10.2 Turbine Generator

The information in this section of the reference ABWR DCD, including all subsections, tables and figures, is incorporated by reference with the following departures and supplements.

**Figure 10.2-1 Turbine Stop Valve Closure Characteristic**

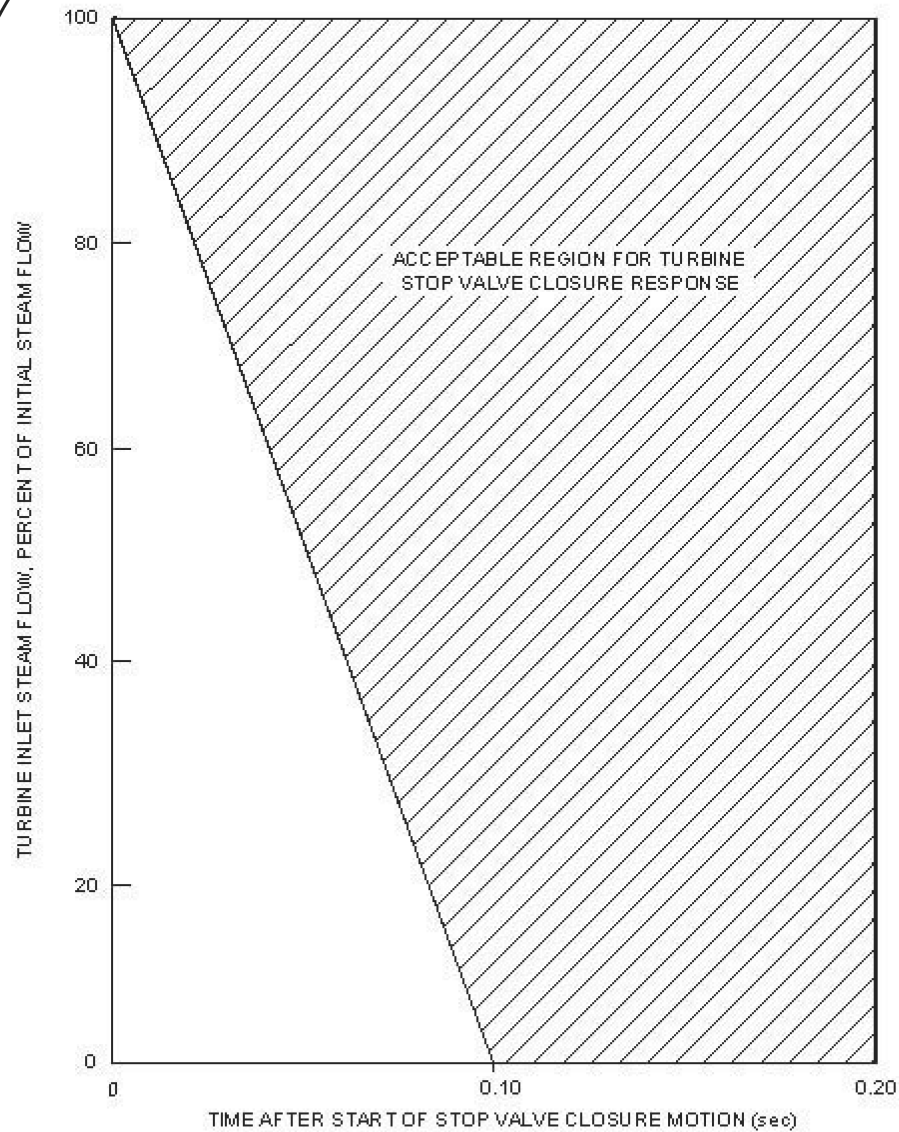
STD DEP Admin (Figure 10.2-1)

Figure 10.2-4 Generator Hydrogen and CO₂ System

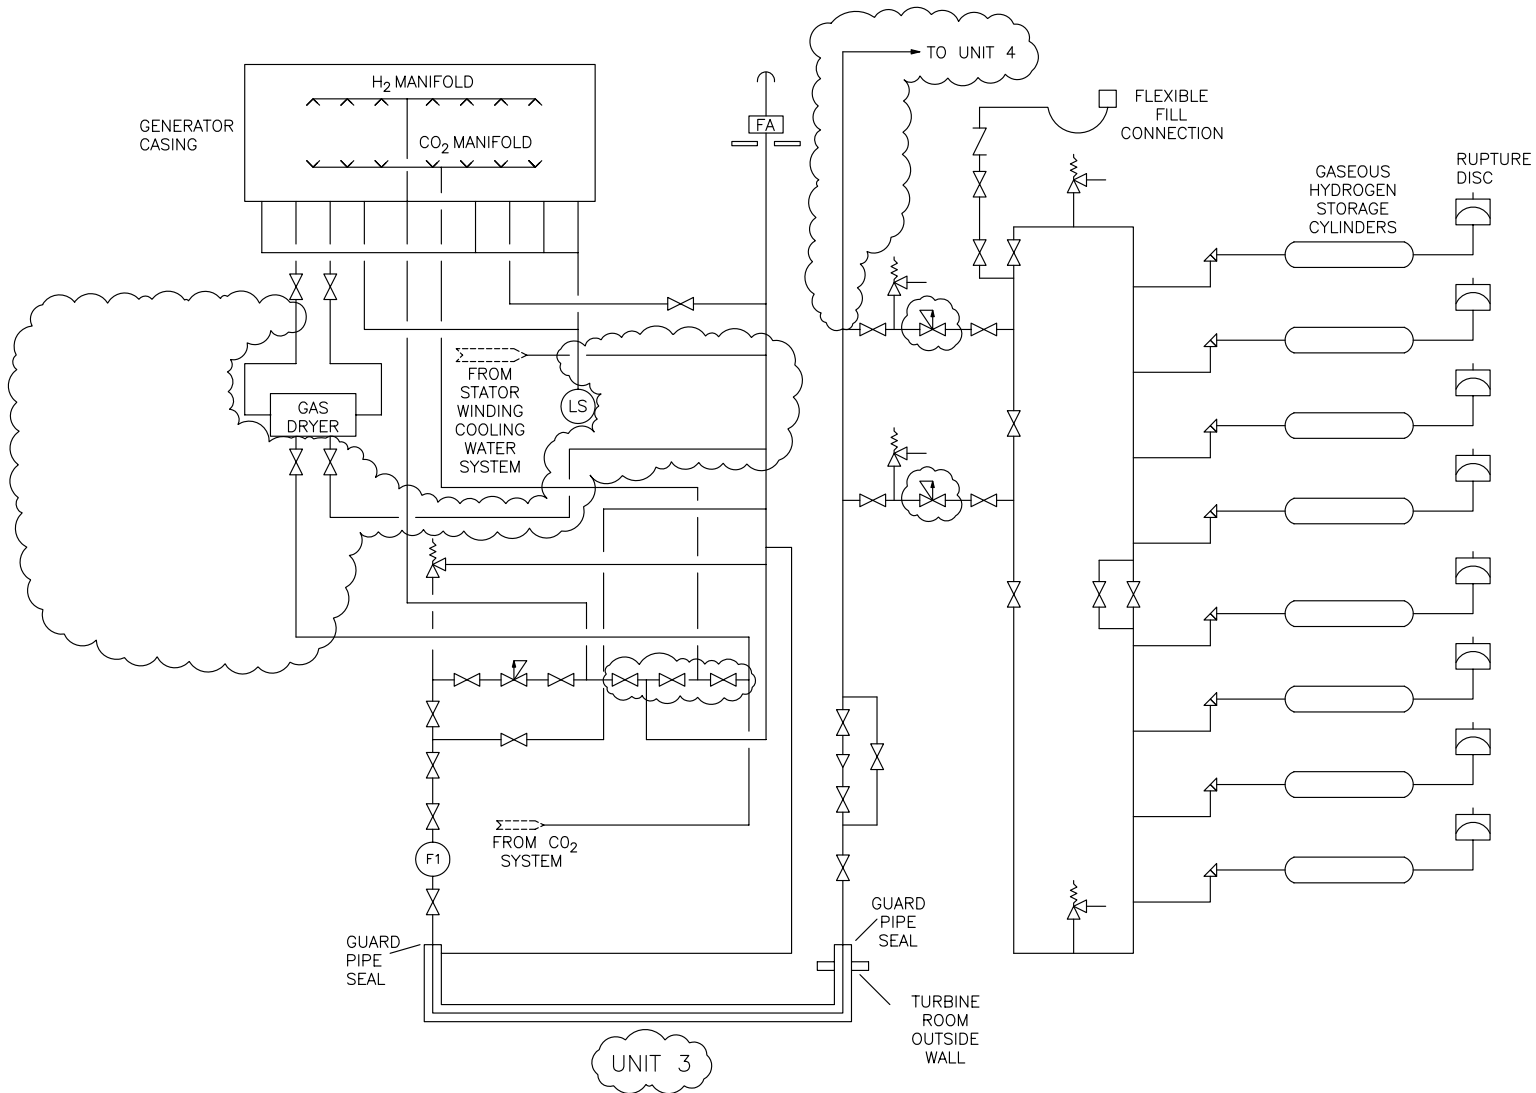
STP DEP 1.1-2 (Figure 10.2-4)

STP DEP 10.2-1 (Figure 10.2-4)

Bulk Hydrogen System—*The bulk hydrogen and CO₂ system is illustrated on Figure 10.2-4. The hydrogen system is designed to provide the necessary flow and pressure at the main generator for purging carbon dioxide during startup and supply makeup hydrogen for generator leakage during normal operation.*

Figure 10.2-5 Turbine Overspeed Trip System Functional Diagram

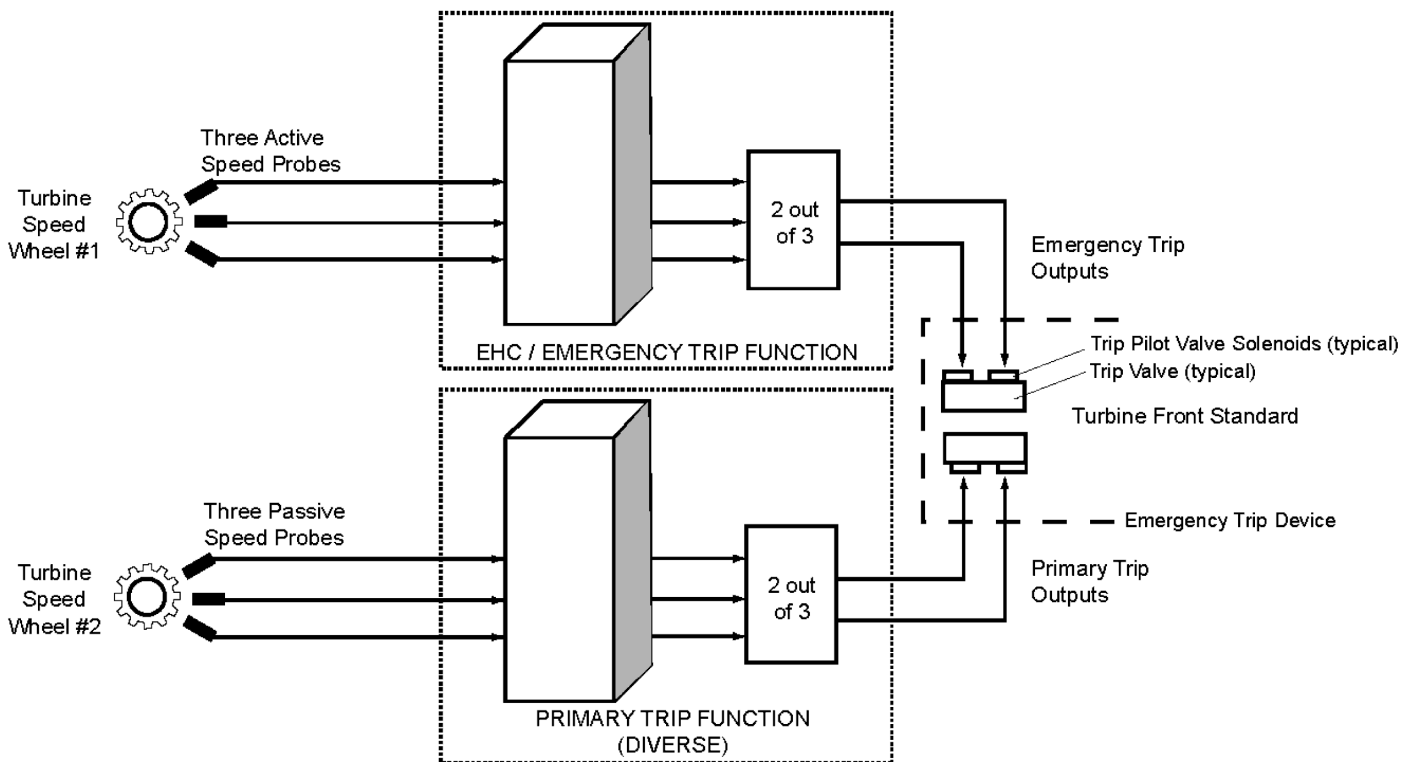
The primary trip function is independent and diverse from the emergency trip function as explained below (refer to Figure 10.2-5, Turbine Overspeed Trip System Functional Diagram). Two-out-of-three logic is employed in both the primary and emergency overspeed trip circuitry. Each trip function can de-energize its associated trip pilot valve solenoids of the electro-hydraulic Emergency Trip Device (ETD). The ETD is composed of two independent trip valves, each with two normally energized fail-safe solenoids. For each trip valve, each trip pilot valve solenoid is powered from a separate power source. The solenoids de-energize in response to detection of an overspeed condition by the turbine speed control logic. De-energization of both trip pilot valve solenoids is necessary to cause the spool in their respective trip valve to reposition, which depressurizes the emergency trip fluid system, rapidly closing all steam inlet valves and indirectly closing the steam extraction nonreturn valves. Accordingly, the repositioning of only one of the two trip valves is necessary to trip the main turbine. A single electrical component failure does not compromise trip protection, and does not result in a turbine trip. Each trip valve in the ETD is testable while the turbine is in operation.

The diverse primary overspeed trip function utilizes three passive speed sensors that are separate from the active speed sensors used for normal speed control and emergency trip function. Speed sensors are diverse (passive and active sensors) between primary overspeed and emergency overspeed trip. Speed sensing for primary

and emergency overspeed trip functions also use separate speed wheels (refer to Figure 10.2-5). Each speed signal for the primary trip function is compared to a speed setpoint of approximately 110% of rated speed, and produces trip signals arranged in two-out-of-three logics, to de-energize both trip pilot valve solenoids of one of the two trip valves of the ETD. Both trip pilot valve solenoids must be de-energized to trip the associated trip valve. The ETD has two redundant trip valves. Tripping of either redundant trip valve will drain the emergency trip fluid, resulting in a turbine trip.
